To:	Ruaridh O'Donoghue	From:	Drainage (Barney Taylor)
------------	--------------------	--------------	--------------------------

Planning App Ref:	PL/2025/09780
Service Ref:	Drainage
Date:	20/02/2026

Outline planning application for the construction of 295 homes; public open space including formal play space and allotments; sustainable drainage systems and associated infrastructure; a 100 place nursery and access points for pedestrians and cyclists. All matters are reserved except for access, the principal point of access is to be provided from a new northern arm onto an improved arrangement of the Eastern Way/A3102 roundabout junction and an emergency access onto the A3102.

Land to the north of the A3102, Melksham, Wiltshire.

Figure 1.1: Modelled Watercourses

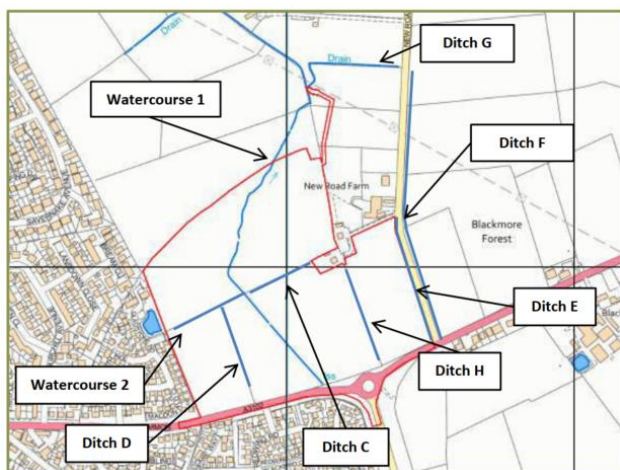
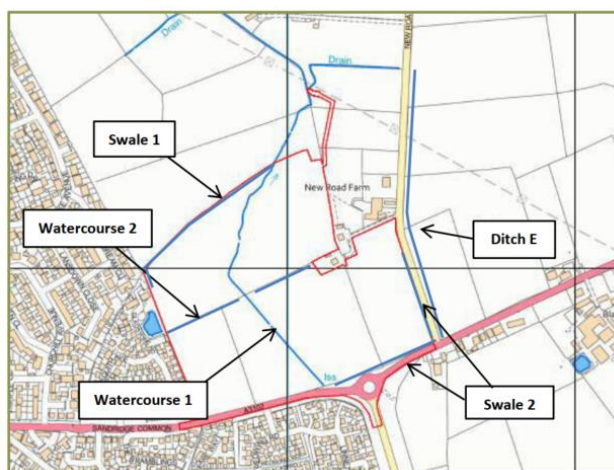
Section 4.5.14 provides the proposed scenario model, which includes several alterations to watercourses, namely Ditch E would be shortened, and Ditch C and H would be 'removed'. The applicant proposes two swales to "alleviate flooding across the development". We note Ditch D has been removed 'from the model'. The two figures below from the Technical Note (SHF.102.003.HY.R.005.B) summarise these alterations.

It is noted that in the proposed model, "flows for all return periods remain in channel, apart from some negligible areas on the left bank of Watercourse 1, in open greenspace. The second small area of flooding is shown to be to the north of Swale 2. Though it should be noted that all dwellings within the Site boundary are located outside the mapped extent of flooding". Additionally, all proposed structures to convey flow have been modelled for the worst case scenario – each include a +600mm freeboard above the 100+71%CC event.

Consequently, the modelling demonstrates the alterations to existing watercourses provides betterment on the existing modelled flood risk scenario on the site. Moreover, as a result of the restricted discharge rate from the site, betterment will be provided for downstream areas of the site.

- c. The applicant is proposing several new culverts introduced on watercourses. The applicant must confirm the culverting has been considered and included within the modelling undertaken – and if not, the modelling should be updated to include all culverts.

Figure 4.1: Baseline Flood Outlines - Overview

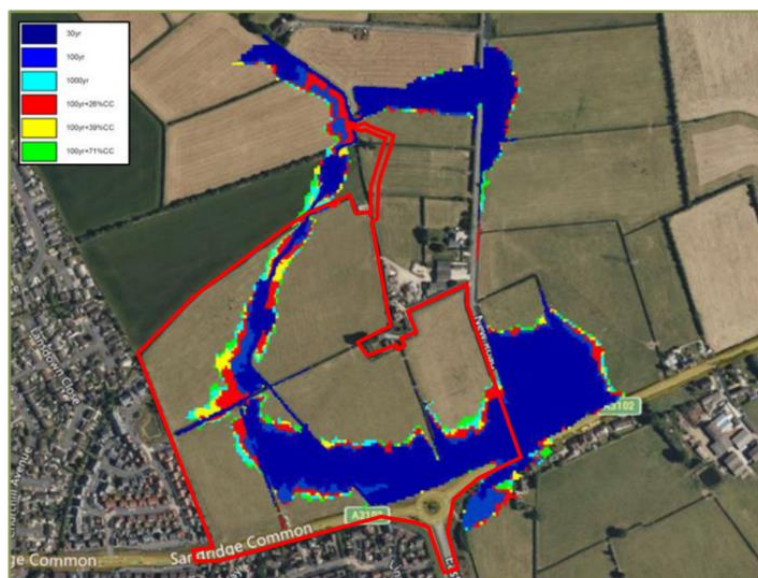
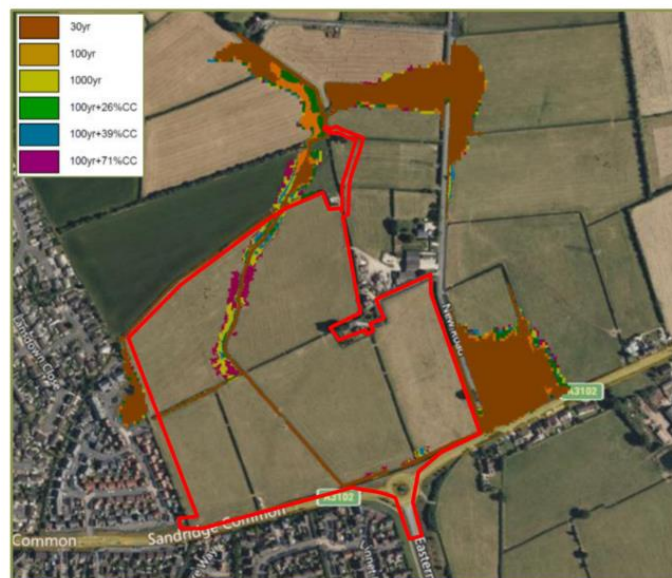
However, a holding objection has been recommend as there is modelled increased flood risk post-development to the upstream western existing pond. The applicant is required to demonstrate there will be no increase to flood risk elsewhere as a result of the development.

Observing the modelled pre-development and post-development flood extents below, the flood risk to the existing western pond is increased post-development. The applicant must provide details outlining how this has been justified, and demonstrate that flood risk will not be increased elsewhere as a result of the development
